Airworthiness Directive Schedule

Yakovlev/Aerostar 3, 18, 50, 52 and 55 Series

27 October 2016

DCA/YAK/5 Elevator Control System Pulley – Inspection and Replacement

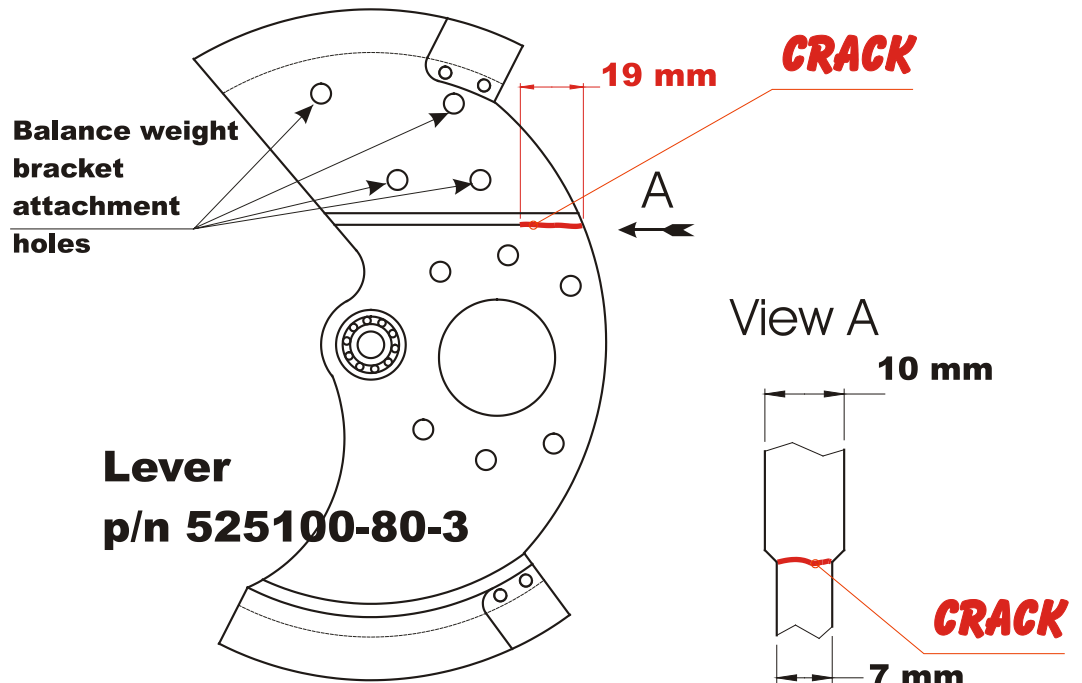
Note: This AD is prompted by a report of finding a 19 mm crack in the elevator control pulley P/N 525100-80-3 (referred to in the Romanian parts catalogue as a “lever”). The failure of this component could result in loss of elevator control.

Requirement: To prevent failure of the elevator balance weight flange/sector/lever P/N 525100-80-3 which could result in loss of elevator control, accomplish the following:

Inspect lever P/N 525100-80-3 for cracks using a dye penetrant method. Inspect in the area below the attachment of the balance weight bracket at the point where the section reduces from 10 mm to 7 mm.

If the lever is found cracked, replace affected parts before further flight.

Inspect the primary stops of the lever for damage and wear. If any defects are found, or if the rubber pads are excessively worn, replace affected parts before further flight.
